TI_2203: Availability of SSR power semiconductors

07/03/2022

Due to the tense supply situation for electrical components on a global level, from March 2022, heat sinks Quad-SSR cpl. will no longer be installed for iCombi 6-2/3, 6-1/1 and iVario 2-XS, 2-S, L and X L.

- iCombi heat sink Quad-SSR Art. no.:40.06.052

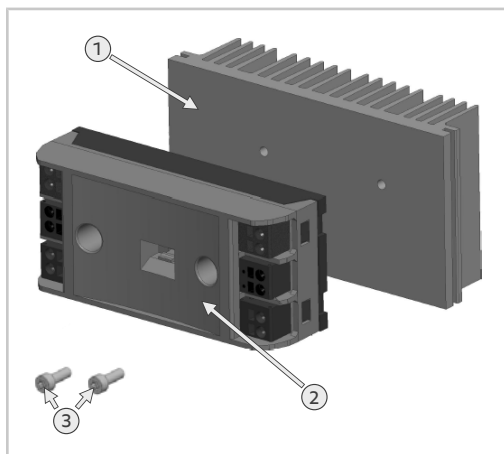
Kit of components installed until February 2022:

1	Heat sink small Quad-SSR	40.06.051
2	Power semiconductor SSR 4-pin 25 A (Quad)	40.05.670P
3	Cylinder screw Torx T20 M4x12	10.00.061

- iVario

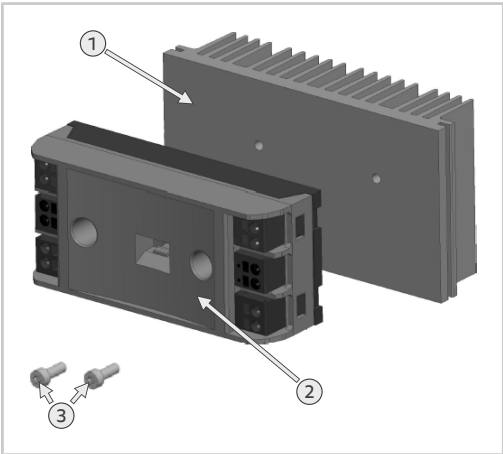
Article numbers of the components installed up to February 2022:

1	Heat sink small Quad-SSR for 2-XS and 2-S	40.06.028P
1	Heat sink small Quad-SSR for L and XL	40.06.428P
2	Power semiconductor SSR 4-pin 25 A (Quad)	40.05.670P
2	Power semiconductor SSR	40.05.840P
3	Cylinder screw Torx T20 M4x12	10.02.263P

- a. Power semiconductor SSR screwable

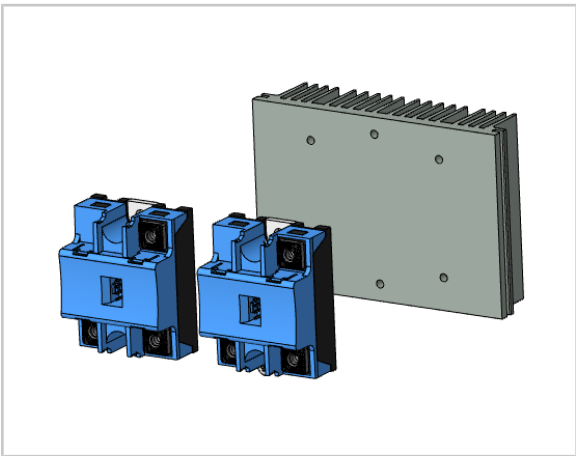
From March 2022, the following components will be installed:

Component	Article number
Power semiconductor SSR	40.01.589P or 40.05.840P
Heat sink small SSR	40.04.795P

Component	Article number
Power semiconductor SSR	40.01.589P or 40.05.840P
Heat sink small SSR	40.03.931P

Component	Article number
Power semiconductors SSR for 2-XS, 2-S, L and XL	40.01.589P
Heat sink SSR for 2-XS and 2-S	40.06.028P
Heat sink SSR for L and XL	40.06.428P
